ELLIANOS COFFEE- 14155 BOGGY CREEK RD

SUMMARY

Staff recommends approval of the proposed MPL2026-10006 subject to the conditions contained in this Staff Report.

SITE PLAN

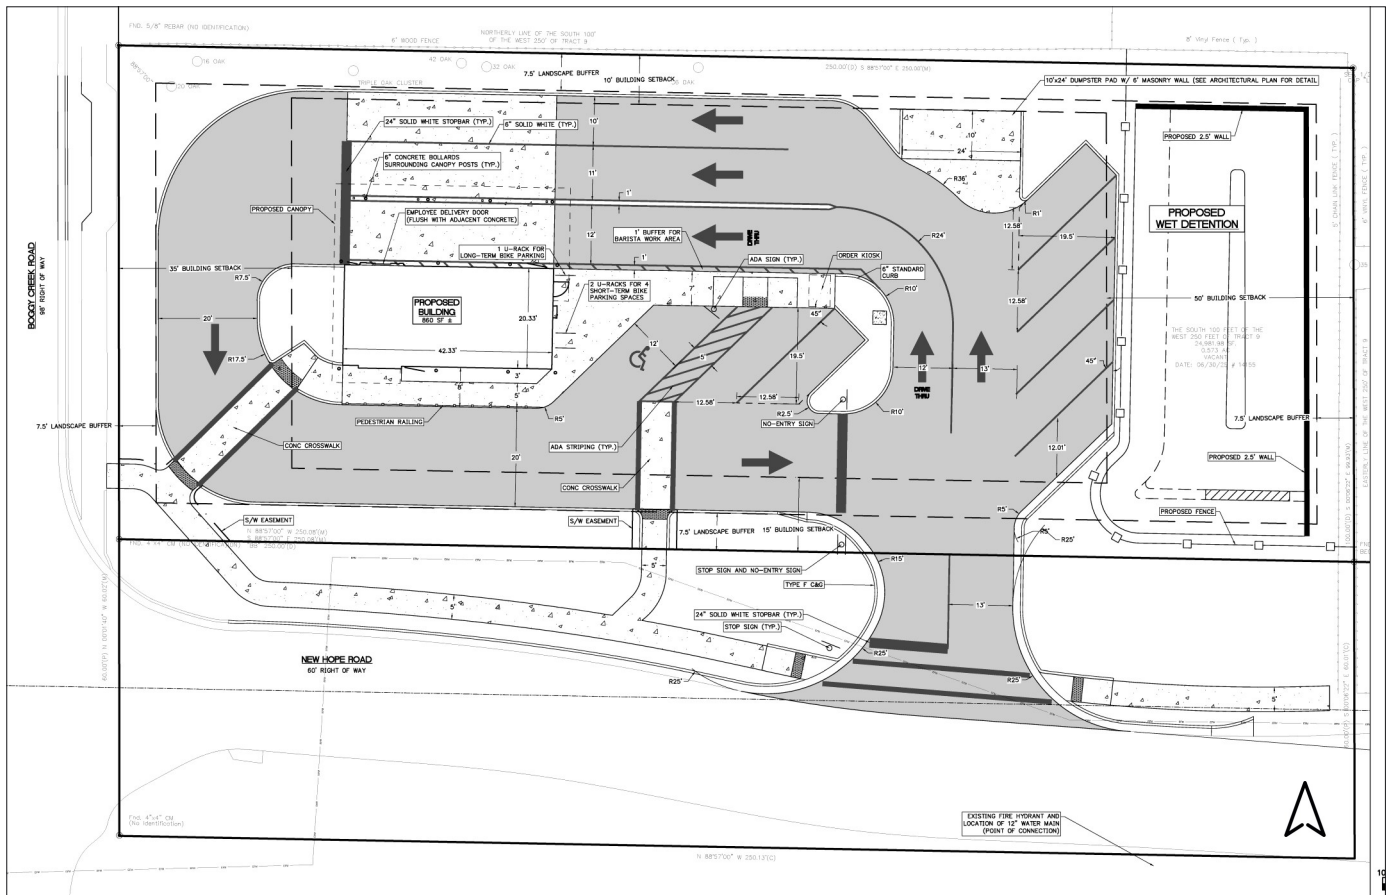
- 10) The number of proposed parking spaces (8 regular and 1 ADA space) is consistent with LDC Sec. 61.322.
- 11) The 45-degree angled parking spaces are not dimensioned consistent with LDC Sec. 61.311 and the ESM. The standard parking spaces must be 12.7-ft. wide rather than 12.56-ft., as shown. At the time of permitting, the site plan must be updated to show all parking spaces with the correct width.

- 12) The ADA parking stall width must be 12.7-ft. wide rather than 12-feet as depicted on Sheet C2.0. At the time of permitting, please update the site plan to show the correct ADA parking stall width per LDC 61.309 and the 2010 ADA Standards for Accessible Design manual.

- 13) Parking: The most northern parking stall, next to the dumpster, does not specify any dimensions. At the time of permitting, please provide the dimensions of all parking stall. Additionally, it's unclear whether the dumpster area reflects a 100-SF clearance area to allow vehicular maneuverability that will not conflict with vehicular or pedestrian movements per LDC 61.35 (c). The dumpster area must always remain clear of obstructions. Provide an Auto-turn analysis at the time of permitting to demonstrate compliance with this land development requirement.

- 14) Parking: At the time of permitting, the applicant must show/demonstrate the transitional grade elevation at the north end of the ADA accessibility aisle. The graphic shown at this location on the site plan is unclear. If the sidewalk is not at grade, a curb ramp will be required.

- 15) Bike Parking: Per LDC Sec. 61.330, the applicant is required to provide 1 long-term and 4 short-term bicycle parking spaces. The site plan shows only 1 long-term and 2 short-term bicycle parking spaces. The 1 long-term bicycle is consistent with the locational requirements of the code. However, 2 additional short-term bicycle spaces will be required to comply with the code requirement for 4 short-term bicycle spaces. The Applicant is required to demonstrate the provision of 4-short-term bicycle spaces at the time of permitting.

- 19) Pavement Marking and Signage Plan (PMSP): Sheet C2.0, depicts the R-1 stop sign and stop bar in the New Hope Road right-of-way (ROW). Typically, these pavement markings and signage elements should be contained within private property. The applicant must obtain permits from Orange County for all work performed and signage within this ROW.

- 25) Easement: The applicant must provide a copy of the recorded easement for any portion of the sidewalk located on private property or record the easement through the replat process. That portion of the sidewalk at the southwest corner, outside the ROW, must be placed into an easement.

LANDSCAPE PLAN

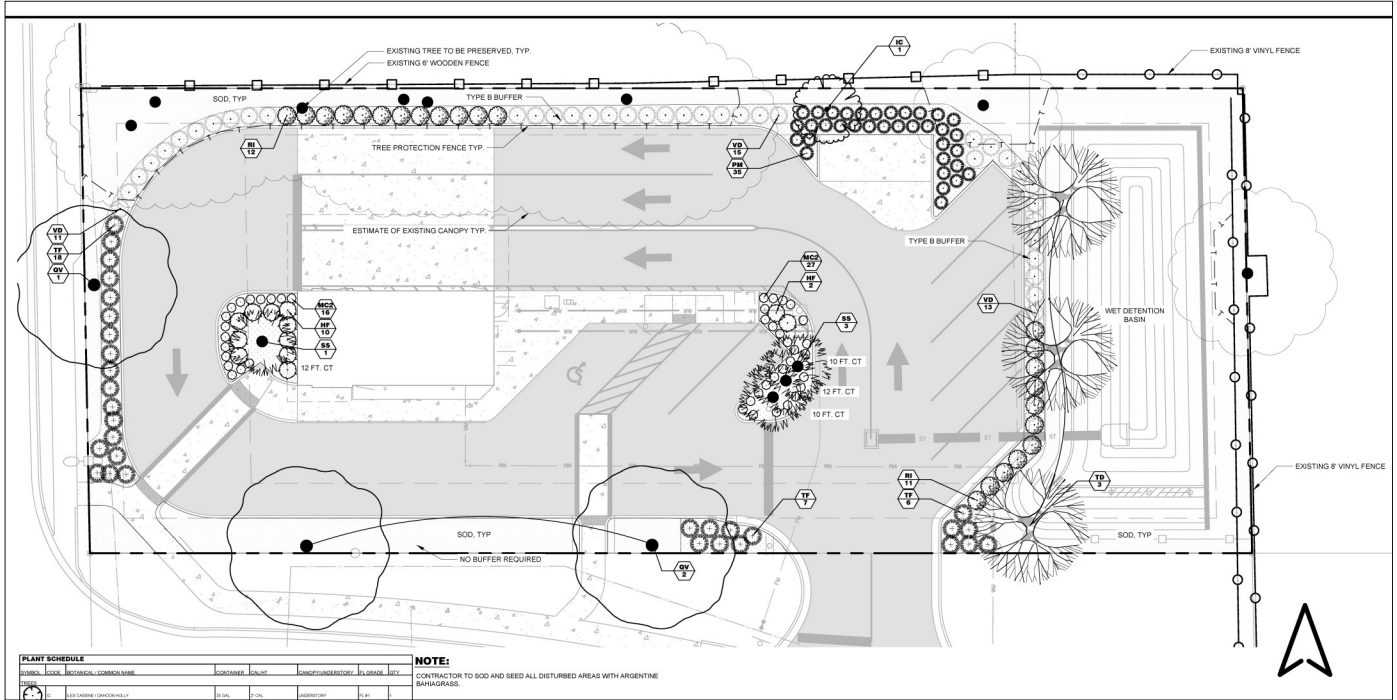
- 9) At the time of permitting, please add a continuous row of evergreen shrubs installed at a minimum height of 36 inches to the street side buffer to screen the vehicle use areas from the street. A bufferyard B, per LDC Section 60.222, must also be provided on the eastern side of the property.

ELEVATIONS (CONT.)

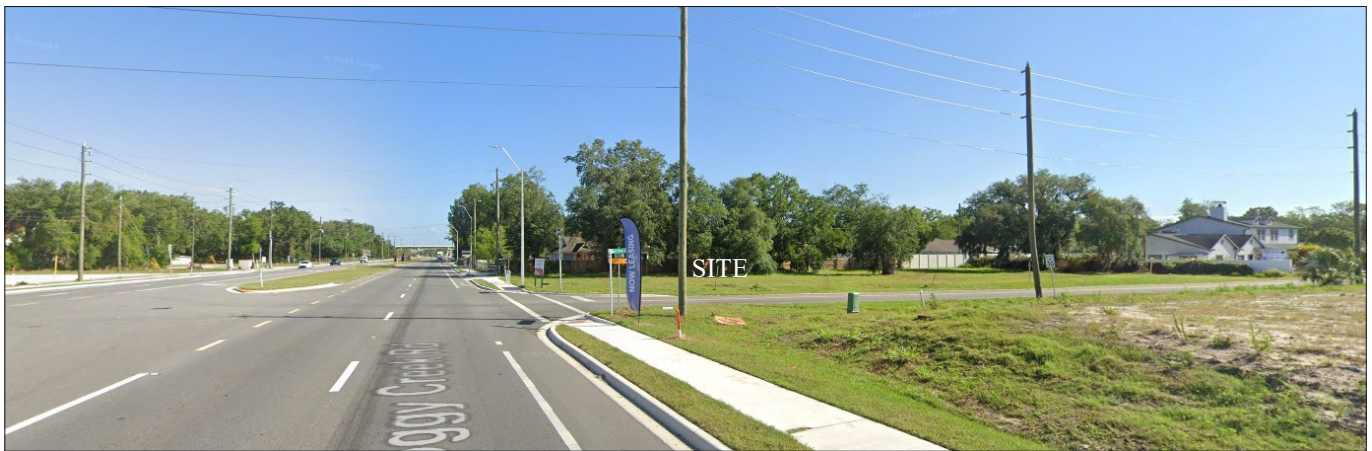
11) The awning above the walk-up window must project out from the façade by a minimum of 5 feet in depth, to provide more shade for pedestrians.

- 4) Primary pedestrian entries must be clearly expressed and highlighted. All entrances must be visible and easily recognizable from the streets and internal drives. Entryways must include a substantial sheltering element such as a porch, awning, arcade, or portico. As a walk-up window is located on the northern elevation, it must meet this requirement.

- 5) The bases of buildings should be designed with durable materials to provide a quality pedestrian experience such as stone, brick, tile, or concrete. Different colored Stucco/EIFS is not an acceptable base material.

- 6) All parapets must have a 3D appearance, with 5-ft typically added so the parapet looks less 2-dimensional.
- 7) Any fencing on the site shall be an open, CPTED approved fence, such as aluminum or wrought iron picket fencing.
